Control No. PCN-16431

PRODUCT/PROCESS CHANGE NOTIFICATION

DESCRIPTION OF CHANGE

Figure 2: New Bonding Diagram

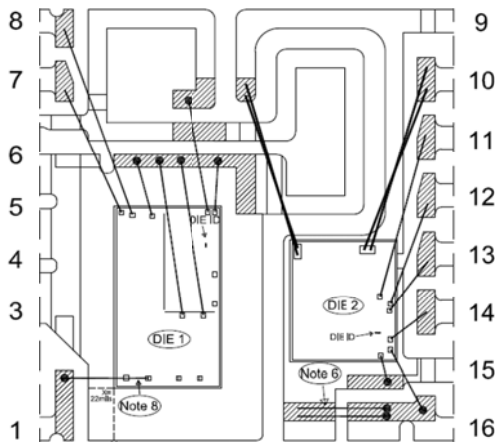
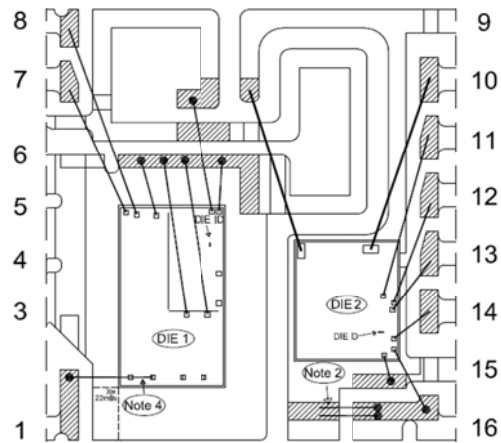
Eliminate a redundant wire each at pins 9 and 10. The current eSOP-R products were introduced with dual wires at pins 9 and 10 for extra mechanical strength during the assembly process. Based on extensive evaluations, it was determined that single wires at pins 9 and 10, as shown in Figure 2, are adequate to achieve the same mechanical strength.
